**DA 2015.130 - Expansion of Existing Sand Quarry at Lot 2 DP 1040274, Woodburn
Evans Head Road, Doonbah
Additional Information**

Please find below and attached our response to the items raised in your letters dated 19 December 2014 and 19 February 2015.

Figure 30: The pH of shallow groundwater obtained from shallow boreholes dug during the infiltration experiments in July 2013. The pH could not be measured in boreholes with a deep groundwater table.

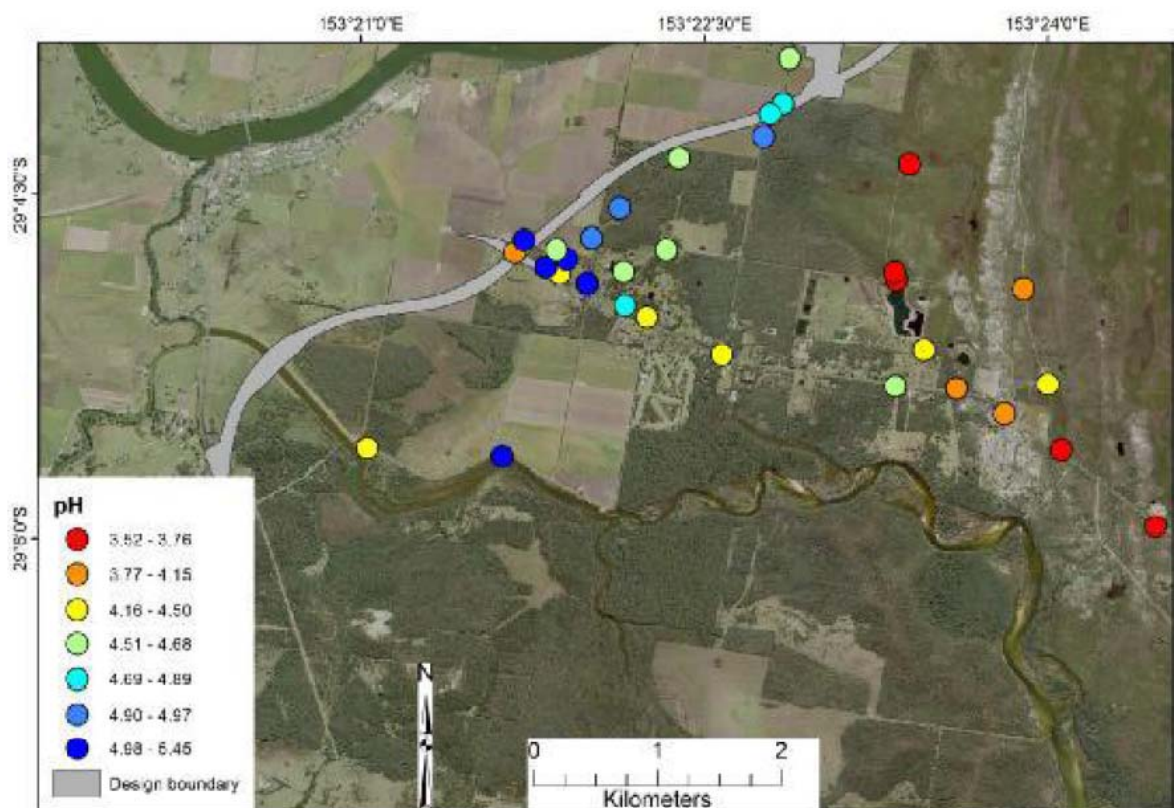
Concerns are raised regarding the elevated concentrations of Aluminium, Copper and Zinc from the single water quality sample collected from the existing pit. Rous Water explains that this is likely to be associated with the prevailing low pH levels and the mobilisation of naturally occurring metals under

these acidic conditions. The groundwater recharge and flow paths in the Woodburn Sand Aquifer using modelling and geochemical approaches (SCU, 2014) indicates the area is characterised by low pH, as shown below. The SCU (2014) report also explains that “these pH values are higher than often observed in shallow acid sulphate soil groundwater in other NSW floodplains (usually in the range of 3-4; de Weys et al., 2011; Johnston et al., 2004)”. The low pH and the associated elevated heavy metal concentrations are therefore likely to be naturally occurring.

In addition, as explained above, the operation is unlikely to discharge offsite, other than during floods, and if it does, the water would need to comply with the EPL requirements. Likewise, we believe a MUSIC model is not warranted.
